Oceana Gold (New Zealand) Limited
P O Box 5442
Moray Place
DUNEDIN 9058

RE: MACRAES PHASE 111 PROJECT-SECTION 92 REQUEST

Please find below our response to Questions 9a and 13a and to relevant sections of Questions 17 to 22.

Figure 11

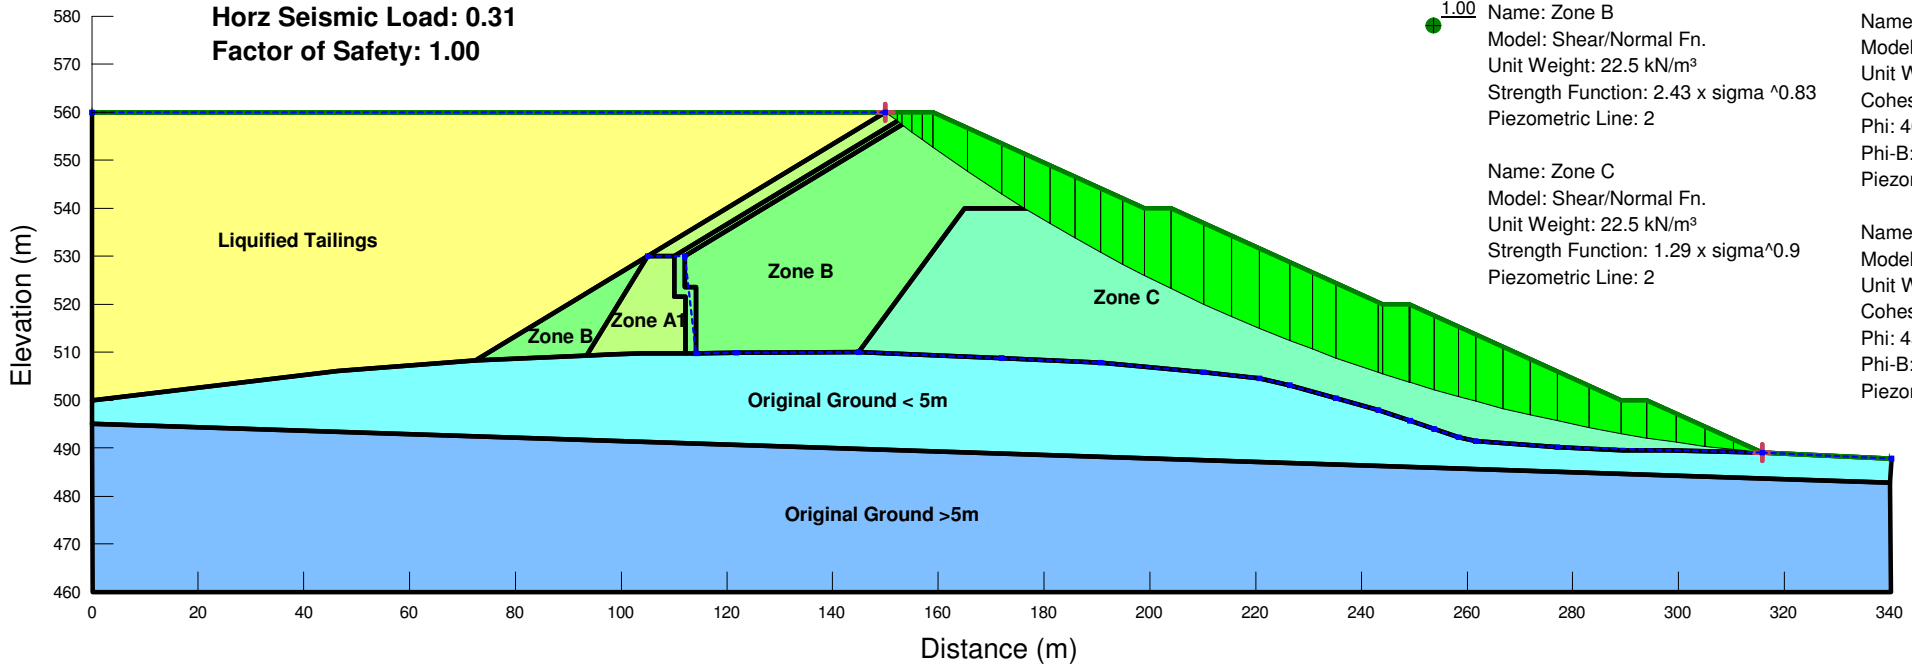
Q9.a) Provide a detailed plan for managing the effects of lake stratification, including options for an intake structure that allows water to be taken from the surface of the lake.

Q21. d) Please confirm whether pressurised conduits will be used in the design.

To reduce the risk of discharge of deoxygenated water from the Camp Creek Dam we suggest a floating decant system for the Camp Creek Dam outlet. Figure 11 (attached) of the Camp Creek Dam Technical report has been revised to show the use of such a system. The decant consists of a 250 OD HDPE pipe. The pipe is anchored and weighted so that it has small negative buoyancy. The inlet consists of multiple small diameter holes drilled into the end of the pipe over an approximately 1.5m length. The end of the pipe is suspended from a buoy or small raft and the inlet depth can be easily varied. The buoy is tethered to the shore by ropes. We have used this design on a number of irrigation dams. It is simple and has proven to be easy to operate and maintain. Generally the inlet is set at about 1-2m below pond level. If this system is adopted the valve shown on the upstream end of the pipe beneath the dam could be omitted. However, in this case a plate that can be attached to the upstream end of the outlet pipe to block it off would need to be available to be installed by a diver if required.

The proposed outlet pipe will be pressurised. It is likely to be a 250 OD PE pipe which will be encapsulated in reinforced concrete over the upstream section as shown in Figures 11 and 12 of the Camp Creek Technical Report.

Figure D7
 3:12:50 p.m.
 1/03/2011

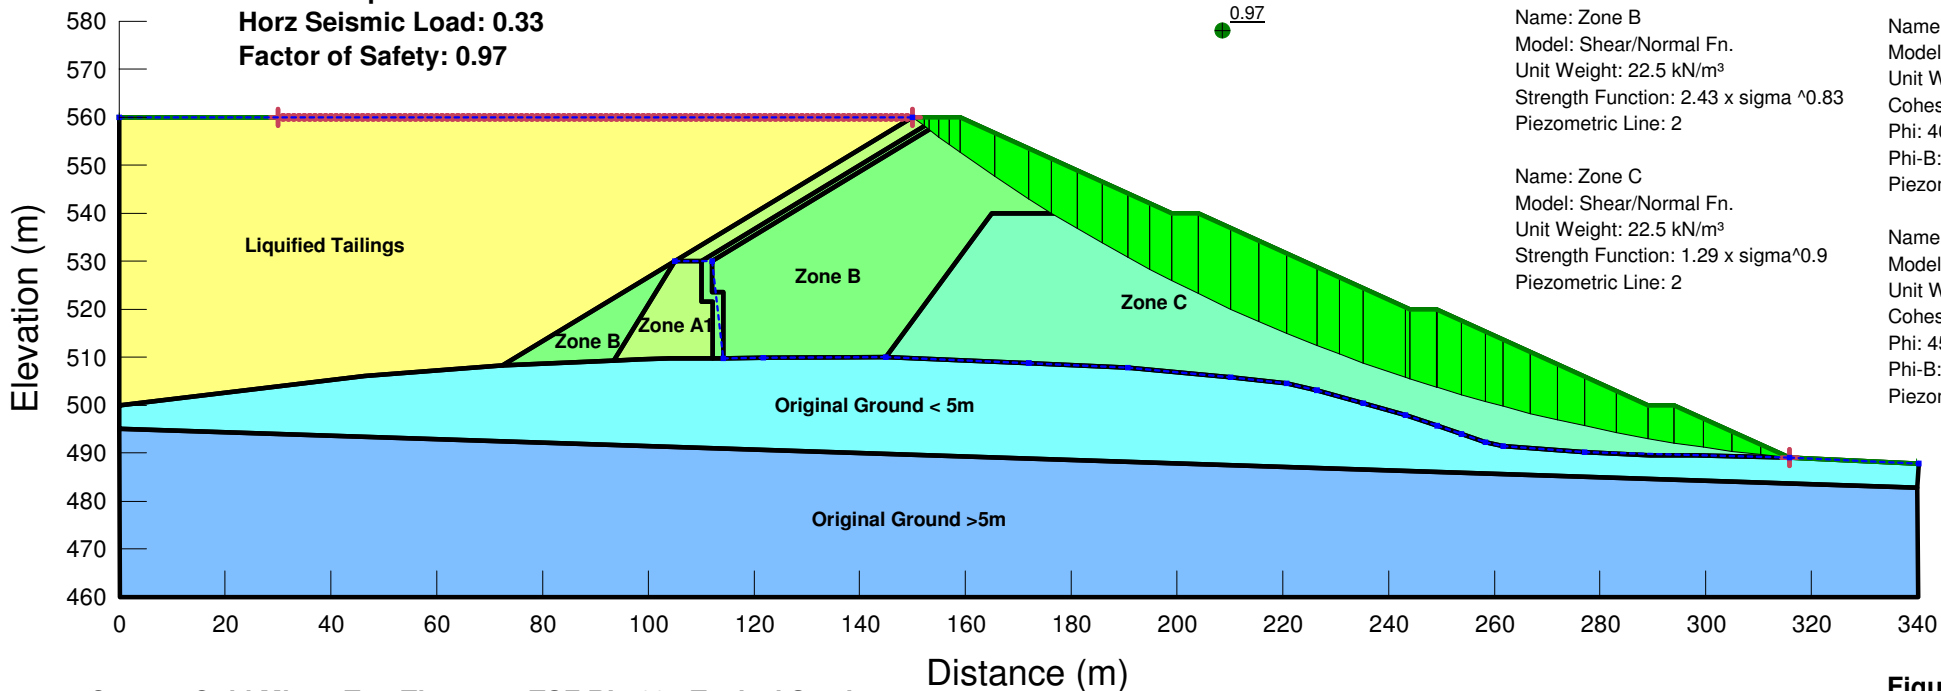
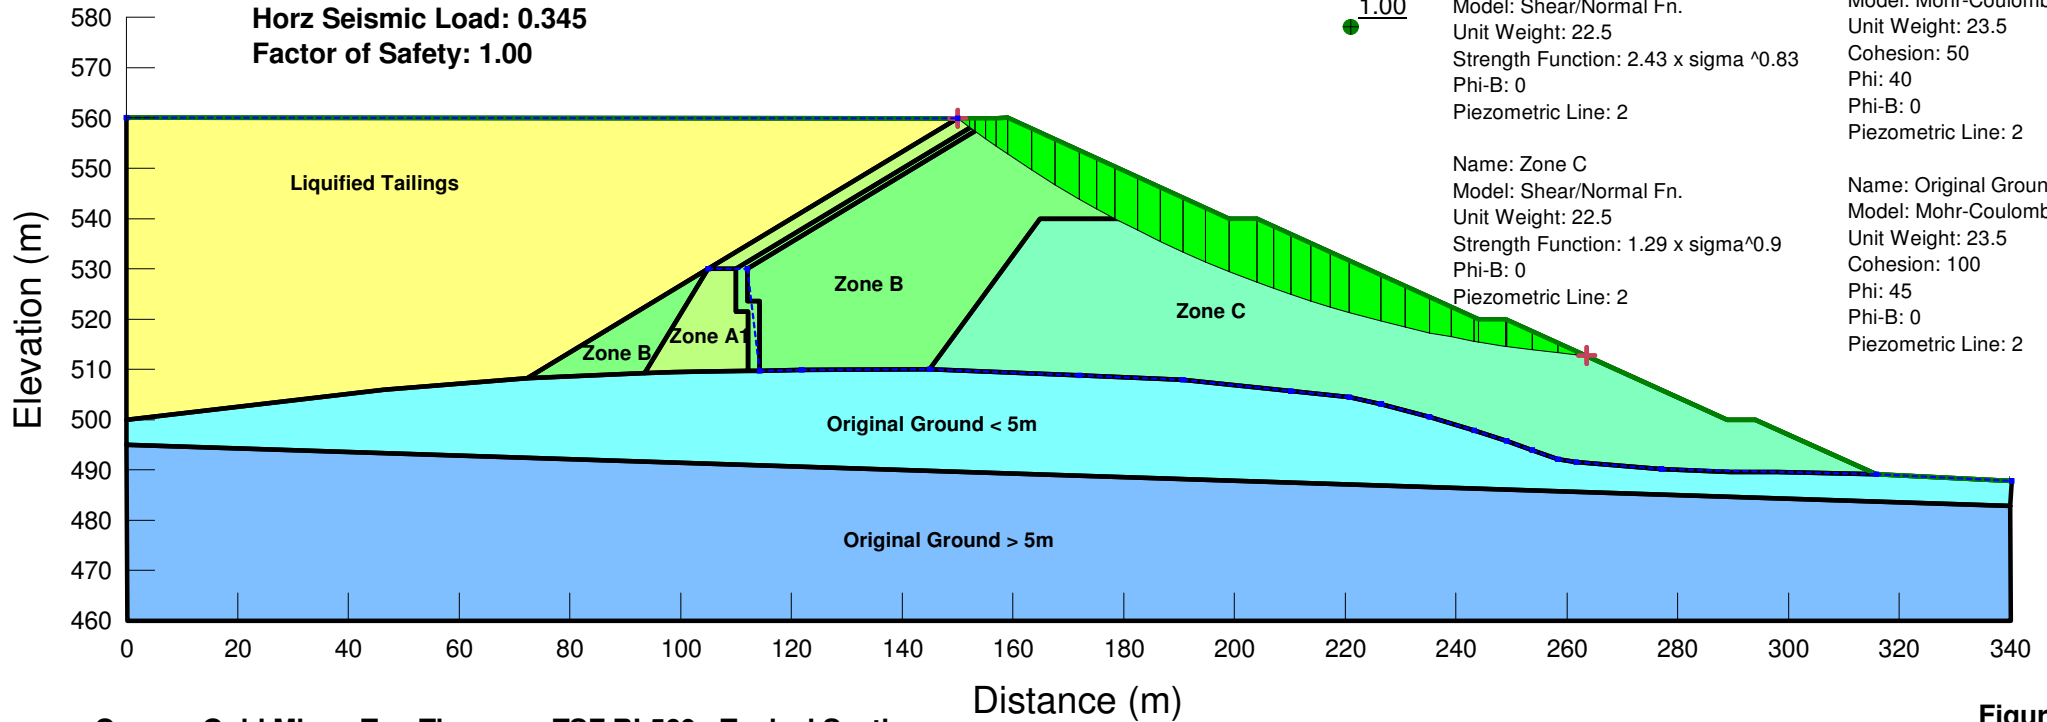
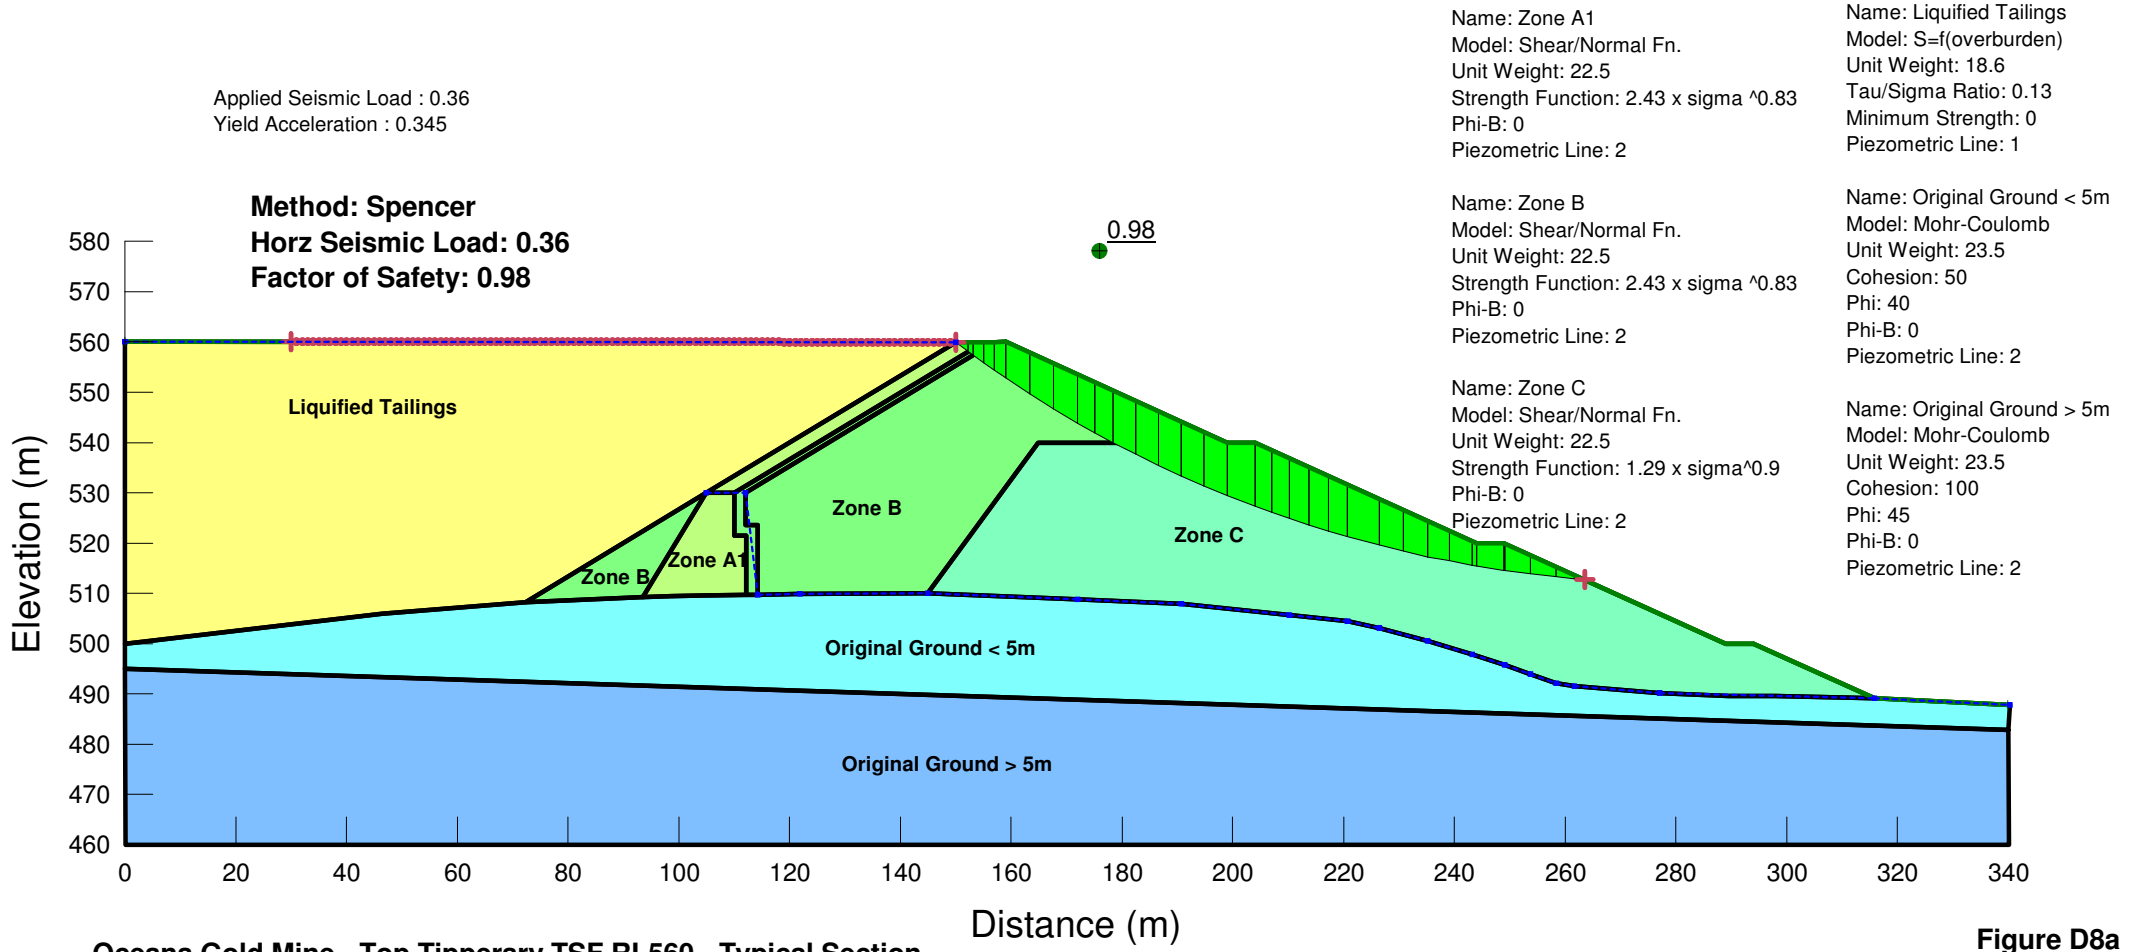
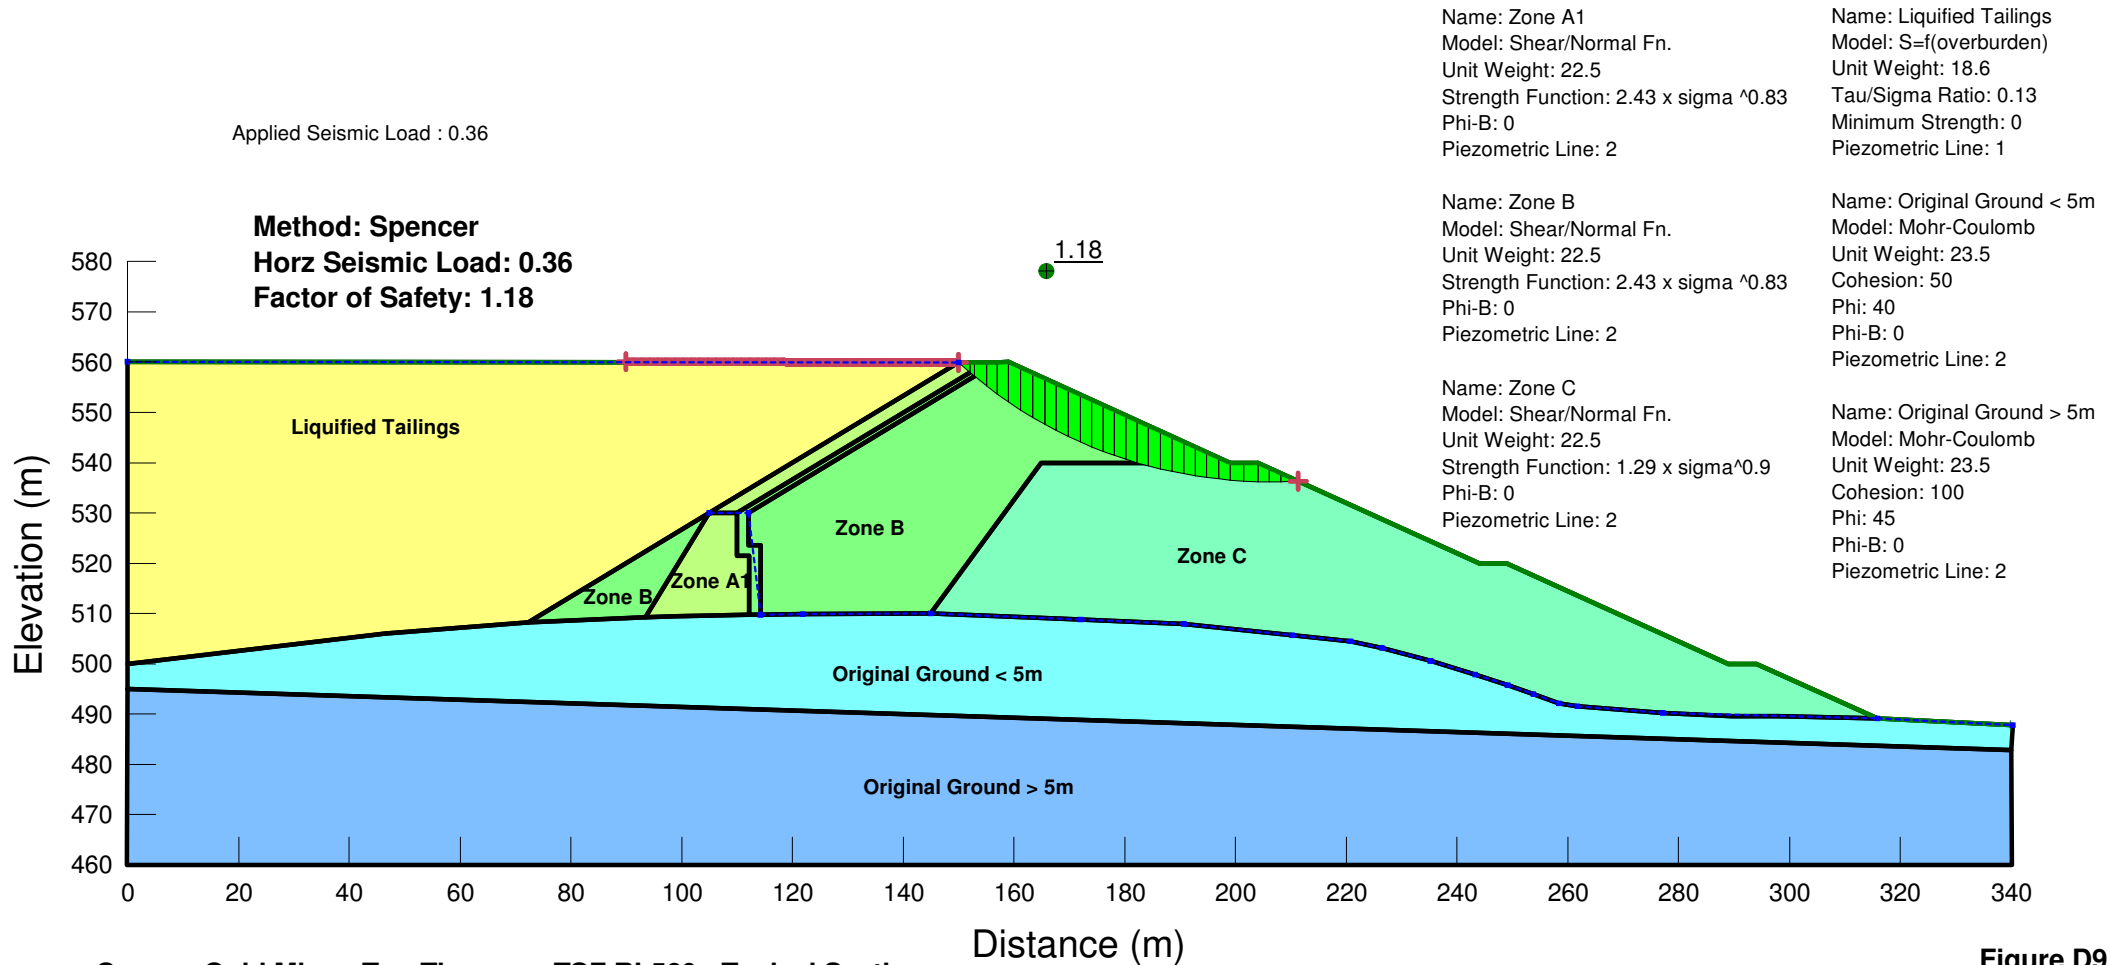
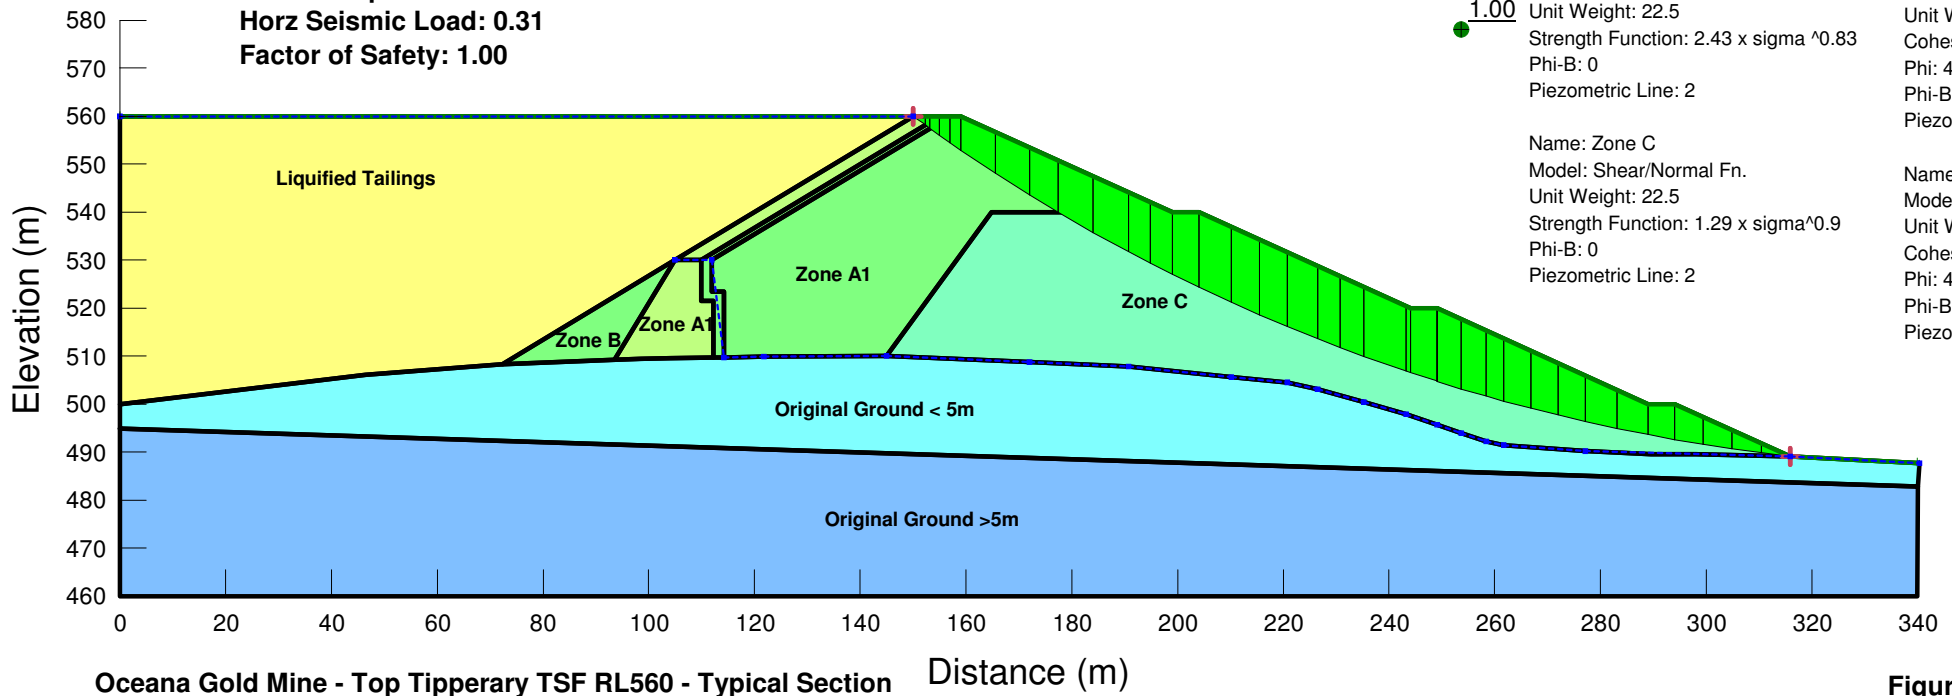
Q17.d) Figures D7 – D12 (appended to the report) show both yield accelerations and design loadings on the same figures. Please clarify the assessed yield accelerations and how these compare with the design earthquake loadings (i.e. OBE & MDE).

Figures D7 - D12 show the yield accelerations for critical circles (i.e. $F = 1.0$). The yield acceleration is equal to the 'Horiz Seismic Load' shown in the figures. The yield acceleration corresponds to the seismic horizontal load when FOS = 1.0. The actual design loadings and yield accelerations, where the FOS is less than 1.0, are summarised in Table D3 of Appendix 3 of the TTTSF Technical Report (Appendix 20 of the application). We note that Table D3 provided in the report has some errors. A correct version is shown below. There is no change to Figures D1 – D6. However we have made some amendments to Figures D7 – D12, specifically to include the design seismic load and the yield acceleration on the Figures and new versions of these Figures are appended. Figure D9 has no yield acceleration because the slope will not yield under the design seismic load. We also include an additional five figures (Figures D7a, D8a, D10a, D11a, D12a) to show the analysis of the embankment under the design seismic load. The FOS is generally less than 1.0 indicating yield and that permanent deformations can be expected.

Loading	kh (g)(1)	kc (g)(2)	Predicted Permanent Deformation (3) (cm)		Depth of Failure Surface	Figure No.
			u50	u5		
475 year	0.33	0.31	0.01	0.02	H	D7
475 year	0.36	0.34	0.00	0.01	$\frac{2}{3}H$	D8
475 year	0.36	-	-	-	$\frac{1}{3}H$	D9
MDE	0.72	0.31	1.7	14	H	D10
MDE	0.72	0.34	1.2	9.5	$\frac{2}{3}H$	D11
MDE	0.8	0.47	0.5	4.1	$\frac{1}{3}H$	D12
